Re: Nelson\Nygaard Sustainable Transportation Report for Mammoth Crossing Project

To: Peter Bernasconi, Town of Mammoth Lakes
From: Jason Schrieber, Nelson\Nygaard
Date: July 3, 2008
Subject: Mammoth Crossing Sustainable Transportation Report

Mammoth Crossing Development: Sustainable Transportation Report

Figure 11: Local Mammoth Crossing Daytime Transit Services

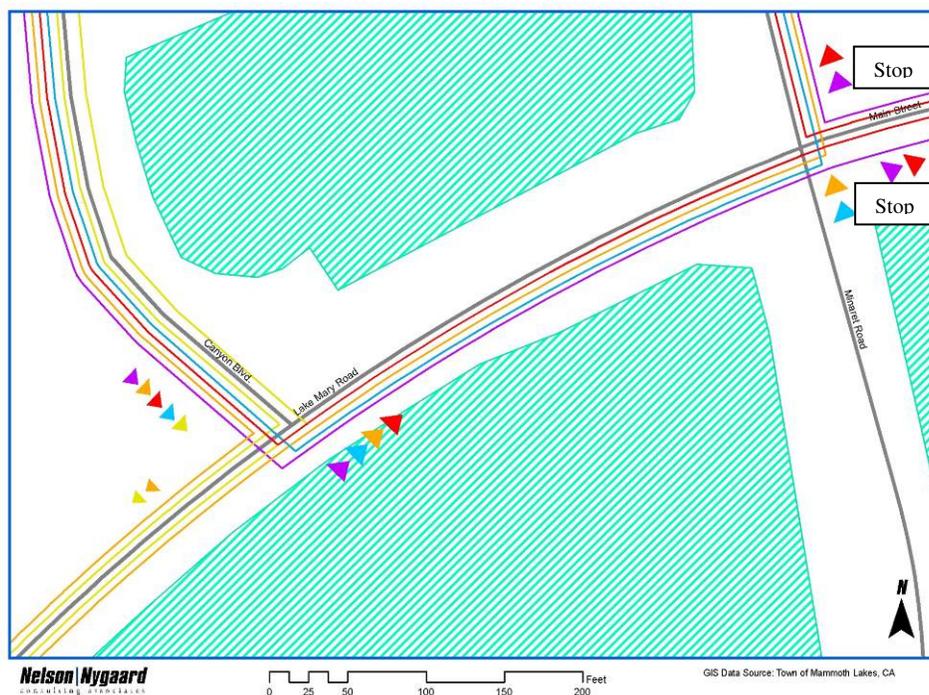
The proposed Mammoth Crossing development is served by nearly all of Mammoth’s transit services (with the addition of the proposed stop on Lake Mary Road). Figure 11 depicts the routes and stops adjacent to the three sites. The six services provide a potential⁴ combined peak frequency from the site to the Town’s transit hub of one bus nearly every 3 minutes and a return frequency approaching 3 minutes. While this level of service is typically considered to be superior, peak service only operates between the hours of 9:00 AM and 5:30 PM, with a maximum early morning frequency of 6 minutes and maximum evening frequencies ranging between 12 minutes and 30 minutes. Furthermore, since any portion of the site is between a 2.5 and 6 minute walk from the Village gondola, only the Red line - with direct service past the transit hub to the main mountain access points - is of significant time-savings value to Mammoth Crossing guests. The Red Line has a maximum frequency of 15 minutes. As noted in Figure 11, its mountain-bound stop is located at the furthest edge of the site, requiring at least one street crossing from all proposed Mammoth Crossing buildings. Therefore, the high quality of transit service in general does not serve this site well as currently configured.

The Mammoth Crossing development has proposed to provide a bus pull-out for one of the four bus stops adjacent to the site. Under current transit circulation patterns, this pull-out would serve only the Blue, Orange and evening Rainbow lines with service towards the Village. For service away from the Village, the pull-out would serve only the Blue, Red and Purple lines. The closest Red and Purple line stop for Village-bound service is at the northeast corner of Main at

Bus pull-outs are mostly beneficial for improving traffic operations. They provide no additional benefit to riders. However, bus stop amenities for waiting riders have the potential to increase the attractiveness of riding transit, and a shelter at this location would be very appropriate. The stop serves workers departing the area on the Blue, Red and Purple lines. Installation of a shelter, information kiosk, heating and/or other stop amenities would significantly increase the utility of transit for employees as well as for guests heading away from the Village to Main Street commercial destinations. Unfortunately, under current transit circulation patterns, these improvements would not benefit riders waiting to head to the main lodge, Eagle Lodge, or out the Orange line.

Figure 13: Entering Peak Hour Vehicle Volumes at Main & Minaret

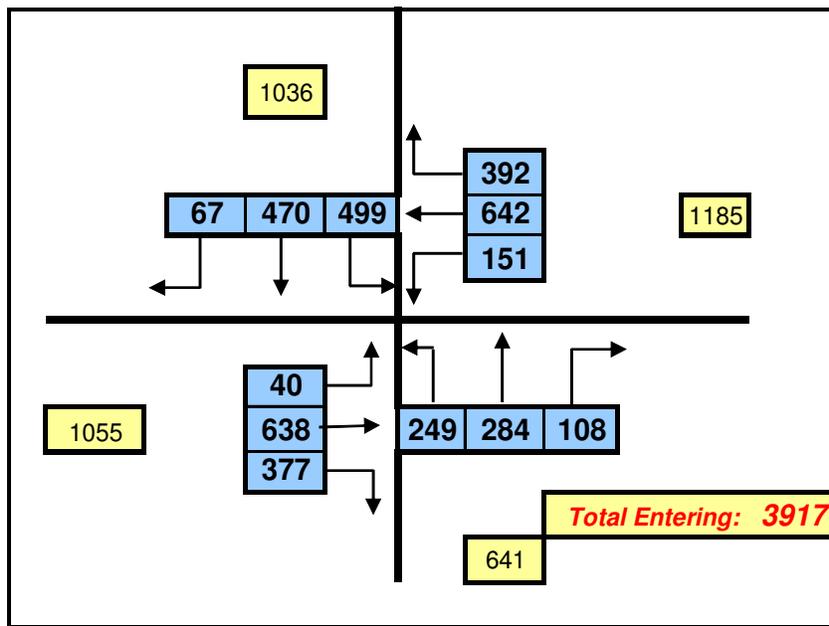
An investigation by some combination of the Mammoth Crossing developer, the Town, and/or CALTRANS of the potential to shorten the crossing distances (at least across Lake Mary and Minaret to the west and south of their intersection) is recommended. A quick review of the existing intersection volumes plus projected traffic from 33 cumulative area projects (per LSA’s analysis) at Main & Minaret reveals that during the Saturday peak, 3,917 vehicles enter the intersection (see Figure 13). Not only is this volume 30-percent of the intersection’s current

capacity, it is only 60-percent of the capacity of an intersection with single-lane approaches⁵. The full build-out of Mammoth Crossing will reduce this spare capacity by only 5-percent. Therefore, the current and proposed roadway configurations are overbuilt, providing ample vehicular capacity while causing significant pedestrian delay.

Figure 16: North Village Specific Plan Pedestrian/Bike Circulation

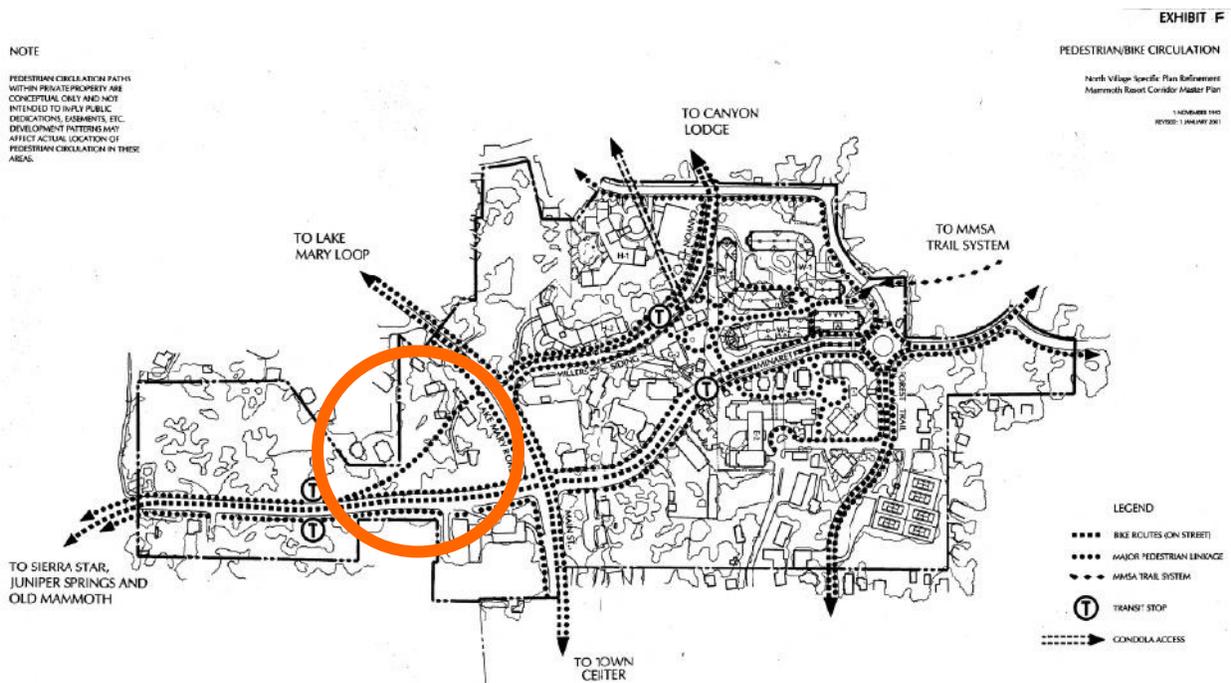
Encouraging this connection – at least for pedestrians – is important to this project, the North Village district, the proposed Sierra Star project, and overall walkability within Mammoth. Sierra Star represents a large population of guests south of the site that will both benefit from the improved pedestrian accessibility as well as contribute to the success of the retail businesses at Site 2. Pedestrians drawn through the site will activate its spaces and provide customers for retail businesses while reducing vehicle trip-making. This enables the North Village to generate sufficient pedestrian activity to create the necessary shift from vehicle trips that is needed to minimize vehicle congestion. Ultimately, greater Mammoth benefits from direct pedestrian connections into the North Village district through key corridors such as this, which had already been clearly identified in the 2000 North Village Specific Plan (see Figure 16 below). While a pedestrian connection accommodating this movement has been provided along the east side of the hotel, additional or stronger connections and obvious visual queues for approaching pedestrians are recommended.

The project itself will also benefit substantially from this connection by welcoming guests and residents of Site 3 to the services of Site 2 (Site 3 has no retail uses proposed). While the proponent has clearly considered this by providing a walkway and crosswalk between the sites, the Minaret frontage does not appear to have clear visual permeability. Mammoth Crossing and Sierra Star might be able to collaborate on their design efforts to increase the interactivity of the two projects.

Figure 17: Site 3 Pedestrian Circulation Issues

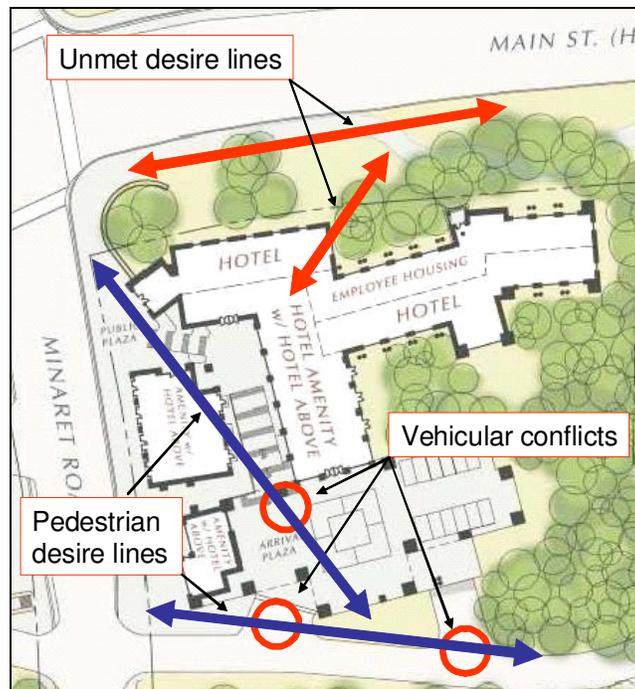
The configuration of the building may be able to be modified somewhat to provide additional pedestrian connections – particularly to Main Street – which would further encourage walking and access to the site. Located at the gateway to the North Village, this site has the unique ability to welcome pedestrian movements to and through the site with clear connections between Minaret and Main. However, due to the steep grade, the building has difficulty connecting to Main Street, and welcoming pedestrian entries have had to be placed only on Minaret (see Figure 17).

The severe grade change that places Site 3 well below the grade of Main Street also can be viewed as a potential opportunity for yet another interesting public space. A grade-level pedestrian entrance on Main Street could connect with an upper floor of the main building, creating a pedestrian entrance and space along the Main Street sidewalk. This connection should be further explored during design development. This also would encourage the development of a more accommodating sidewalk along Main Street.
